Access Compliance Report Public Rights-of-Way (Curb Ramps)

Main Street: FLINT_DR		Cross Street: SANTA_CLARA_AVE		Location:	NE
ADA ID: RPAT211019091612	Ramp Type: Type 4 - Parallel	Initial Pass/Fail: Pass	Overall Compliance: No	Severity Score:	0
Codes/Mitigation Info/Possible Solution			Field Measurements/Component Compliance

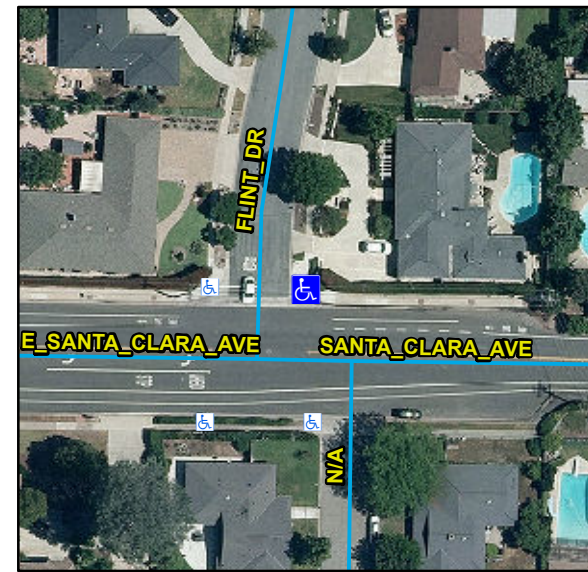
Crossing 1 Slope (%)	0.9		Crossing 2 Slope (%)	8.9
	Crossing 1 Cross Slope (%)	3.9		Crossing 2 Cross Slope (%)	0.7
No	Gutter Ponding	Yes	No	Curb Slope	9.3
Yes	Gutter Lip Height (in)	0		Road Run Slope (%)	1.5
Yes	Gutter Run Slope (%)	3.7		Road Cross Slope (%)	2.3
Yes	Gutter Cross Slope (%)	1.4	Yes	Perpendicular Joint Present	Yes
Yes	Overall Surface Condition	Acceptable			
	Cross Gutter Present?	Yes		Spandrel Present?	Yes
	Replace Cross Gutter?	No		Replace Spandrel?	No

Remove & Replace Curb Slope.

R304.2.2, R302.7, STD 1115
